# Access Compliance Report

## Public Rights-of-Way

Intersection ID: 28077	Main Street: PROVIDENCE_RD_WEST	Cross Street: TOLLIVER_DR	Location:	N
ADA ID: 354A661D1AC3	Ramp Type: Perp	Initial Pass/Fail: Fail	Overall Compliance: No	Severity Score: 8.75
Codes/Mitigation Info/Possible Solution		Field Measurements/Component Compliance

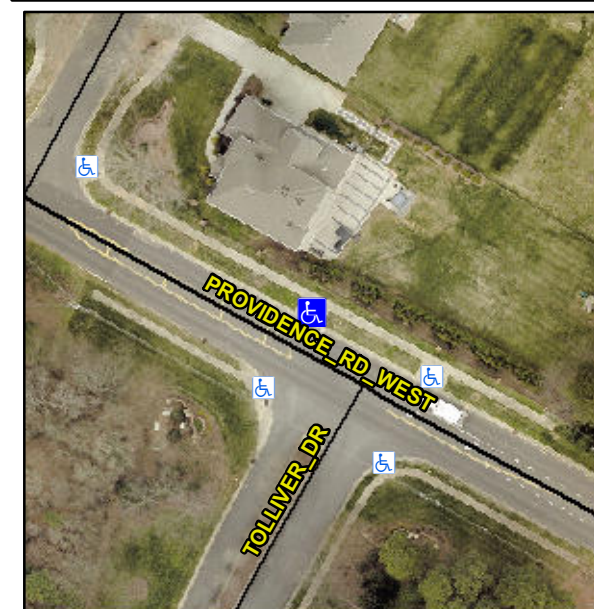
**R304.5.1**

Compliance	Description	Data	Compliance	Description	Data
N/A	Ramp Length (in)	94.0	Yes	Ramp Slope (%)	7.4
No	Ramp Width (in)	47.0	Yes	Ramp XSlope (%)	0.5
N/A	Flare Type LT	N/A	N/A	Flare Type RT	N/A
N/A	Flare Slope LT (%)	N/A	N/A	Flare Slope RT (%)	N/A
N/A	Flare Traversable LT?	N/A	N/A	Flare Traversable RT?	N/A
N/A	Landing Length (in)	N/A	N/A	DWS Provided?	N/A
N/A	Landing Width (in)	N/A	N/A	DWS Contrast?	N/A
N/A	Landing Slope (%)	N/A	N/A	DWS Length (in)	N/A
N/A	Landing X Slope (%)	N/A	N/A	DWS Full Width?	N/A
N/A	Landing Curb? (Y/N)	N/A	N/A	DWS Offset (in)	N/A
N/A	Shared Landing?	N/A			
N/A	Gutter Ponding?	N/A	N/A	Gutter Slope (%)	N/A
N/A	Gutter Lip Ht (in)	N/A	N/A	Gutter X Slope (%)	N/A
N/A	Painted X Walk1?	No	N/A	Painted X Walk2?	N/A
	X Walk 1 Direction	To SW		X Walk 2 Direction	N/A
N/A	X Walk 1 Width (in)	N/A	N/A	X Walk 2 Width (in)	N/A
	X Walk 1 Slope (%)	2.9		X Walk 2 Slope (%)	N/A
	X Walk 1 X Slope (%)	1.0		X Walk 2 X Slope (%)	N/A

**Remove & Replace Entire Ramp.**
